100/300 AREA UNIT MANAGERS MEETING
APPROVAL OF MEETING MINUTES

November 4, 2010

100 & 300 AREA UNIT MANAGER MEETING MINUTES**Groundwater and Source Operable Units; Facility Deactivation, Decontamination, Decommission, and Demolition (D4); Interim Safe Storage (ISS); and Mission Completion****November 4, 2010****ADMINISTRATIVE**

100 D/DR AREA
FY08 REMAINING SITES REMEDIAL ACTION
CIVIL PLOT PLAN - 4: 100-D-8

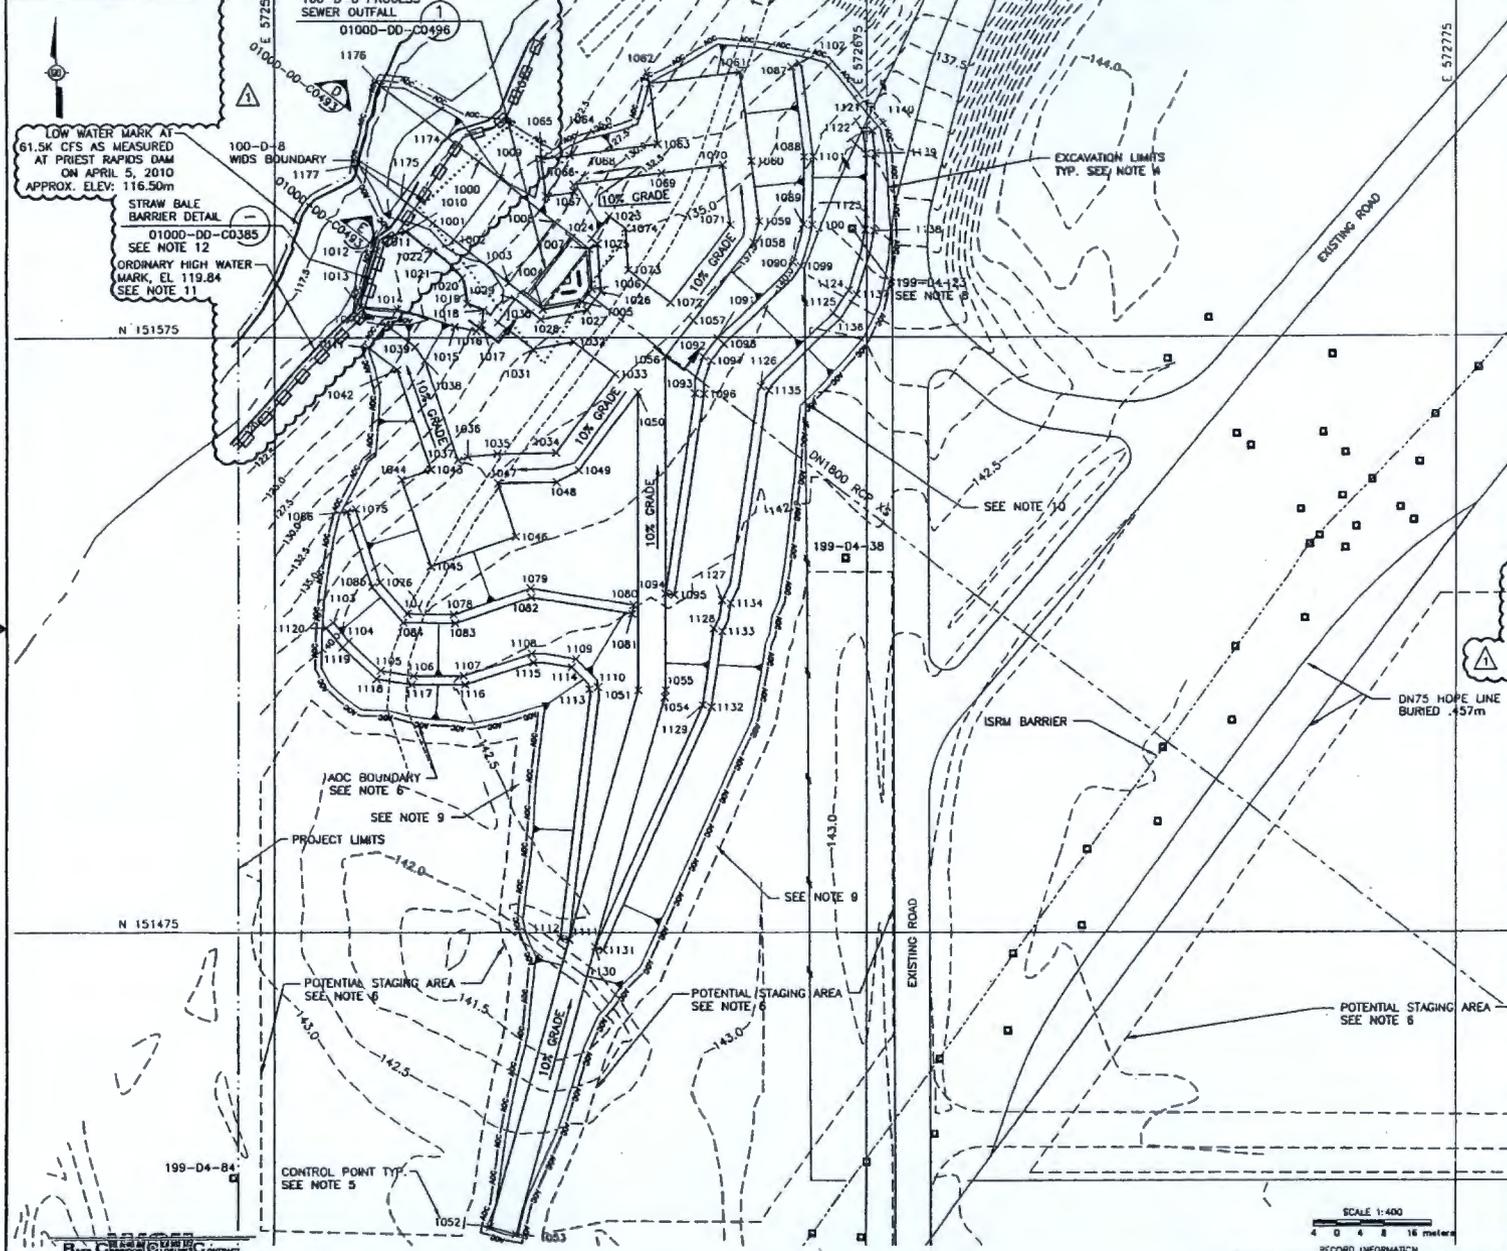
2. The PRSVP for 100-D-8, Figure 2, shows a large magnetic anomaly. Please clarify whether it is anticipated that this anomaly will be encountered during excavation and/or how it will be addressed in the remediation strategy.

100-D-8 – Per the comments provide the final drawings when completed.
